2.0 SITE CHARACTERISTICS

2.1 Geography and Demography

Figure 2.3.2-1 - Vogtle 1998–2002 Hourly Stability Class Frequency

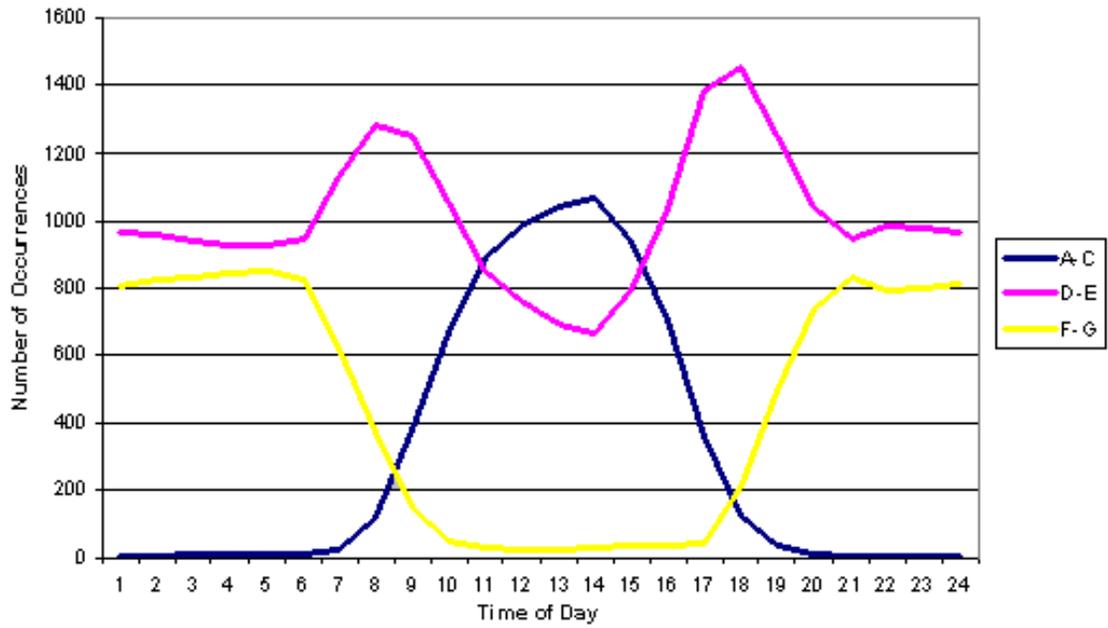
As a qualitative check of the hourly stability data provided by the applicant, the staff created plots of stability class as a function of time of day for each individual year, and, additionally, the 5 years together. SER Figure 2.3.2-1 is a plot of the proposed VEGP site 1998–2002 hourly stability class data as a function of time of day. Unstable conditions (Pasquill stability classes A–C) generally occurred during the day, and stable conditions (Pasquill stability classes F–G) generally occurred during the night, as expected due to daytime heating and nighttime cooling.

During a site audit conducted on December 6, 2006, the staff asked the applicant to explain a daytime increase in the number of occurrences of stable conditions (Pasquill stability classes F and G) in 2001, which is not seen in the other years. The applicant responded, in its letter dated January 30, 2007, that this could be attributed to a data error. This error was corrected in the revised meteorological database. The staff has confirmed that this problem has been fixed.

Figure 2.3.3-1 - Proposed Layout for VEGP Site

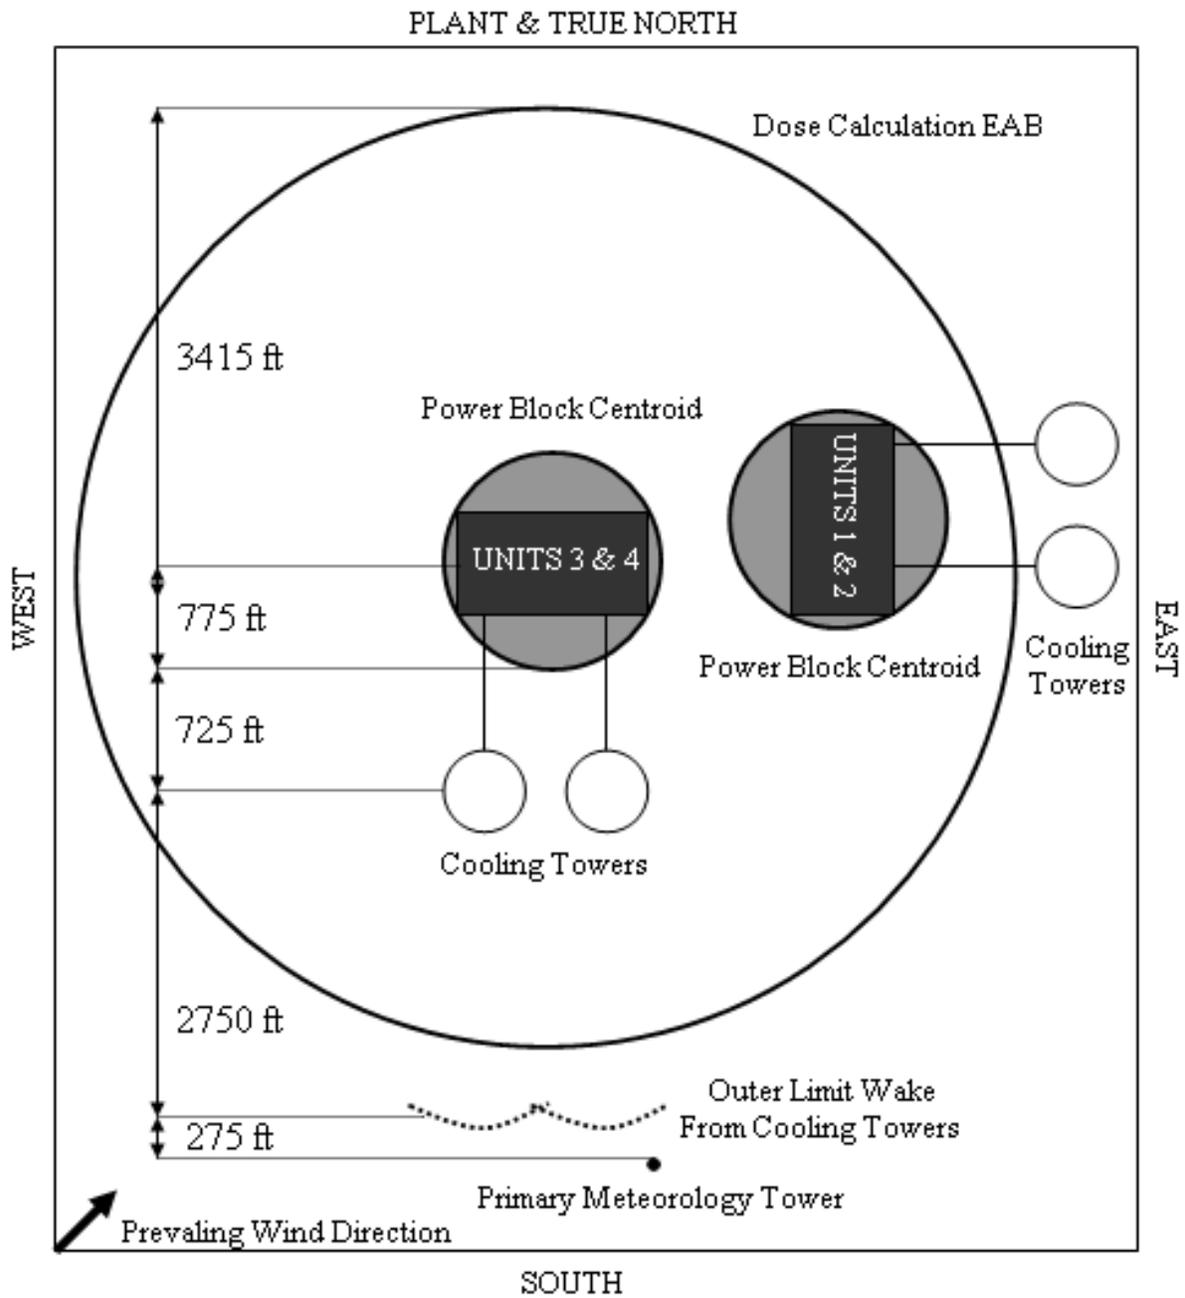
The base of the primary tower is at an elevation similar to plant grade for the proposed facility, and the ground cover at the base of the tower is primarily native grass. The applicant stated that it evaluated minor structures in the vicinity of the primary meteorological tower as having no adverse effect on the measurements taken at the meteorological measurement tower. After

conducting a site audit on December 6, 2006, the staff agrees with the applicant that the meteorology towers are sited in an appropriate area and these minor structures will have no adverse impact on the accuracy of measurements. The staff also noted during its site audit that the meteorology towers are located far enough from the surrounding tree line to prevent adverse effects on measurements. SER Figure 2.3.3-1 shows the proposed layout of the VEGP site.
